**NEW SPRINGHILL ESTATES SUBDIVISION, UNIT
NO. 2, RESUBDIVISION OF LOT 82**

APPLICATION NUMBER 19 DATE November 1, 2007

DETAIL SITE PLAN

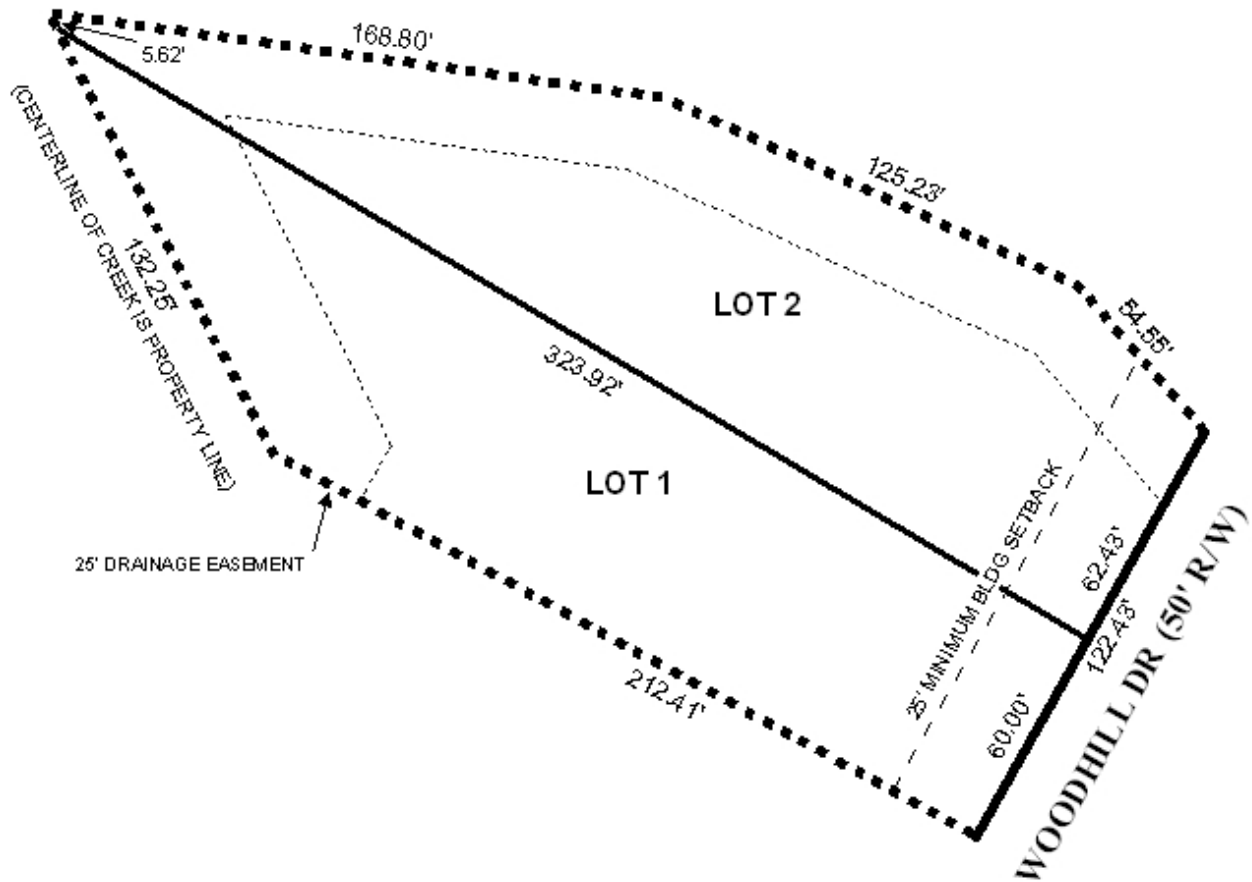
The plat illustrates the proposed 0.8± acre, 2 lot subdivision, which is located on the West side of Woodhill Drive, 200'± South of Ursuline Drive, in city council district 7. The subdivision is served by city water and sanitary facilities.

The site fronts Woodhill Drive, a minor street, with adequate 50' right-of-way. As a means of access management, each lot should be limited to one curb cut, with the size, location, and design to be approved by Traffic Engineering and conform to AASHTO standards. The plat illustrates the 25' minimum building setback line along Woodhill Drive, whereas the subdivision was originally recorded with a 40' minimum building setback line.

The plat labels each lot with its size in square feet, and this information should also be labeled on the final plat, or a table should be provided furnishing the same information.

As proposed, each lot would exceed the depth-to-width ratio of Section V.D.3. of the Subdivision Regulations. Also, long, narrow lots are not typical of the surrounding subdivision; therefore, this resubdivision would create lots which are not characteristic of the area, as stated in Section V.D.1. of the Subdivision Regulations.

Based upon the preceding, it is recommended that Section V.D.3. not be waived and the subdivision be denied for the following reasons:

- 1) both lots would exceed the depth-to-width ratio as stated in Section V.D.3. of the Subdivision Regulations; and
- 2) neither the size nor configuration of either lot would be characteristic of the area, as stated in Section V.D.1. of the Subdivision Regulations.
